SUBJECT: **NEW VEHICLE DEMONSTRATION / DELIVERY HOLD**
Safety Recall 22S27 - Supplement # 7
 Certain 2020-2022 Model Year Explorer Vehicles
 Rear Axle Bolt Fractures

New! REASON FOR THIS SUPPLEMENT

- *Attachment VI Technical Information: Updated the axle nut torque specification to the correct value.*

FIGURE 2

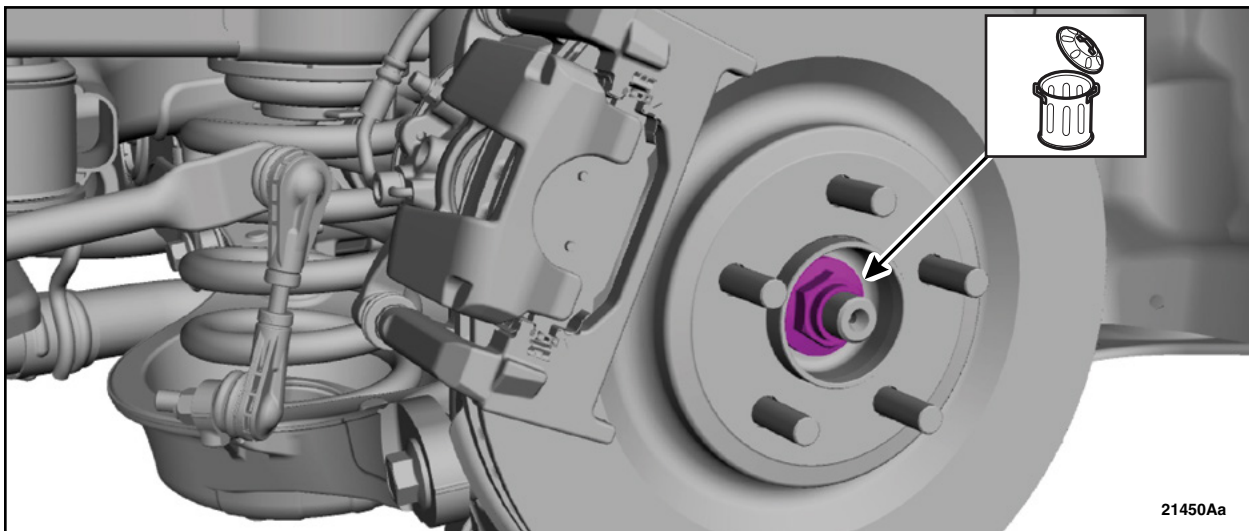
5. Remove and discard the wheel hub nut. See Figure 2.

• *Torque: 300 Nm (221 lb.ft).*
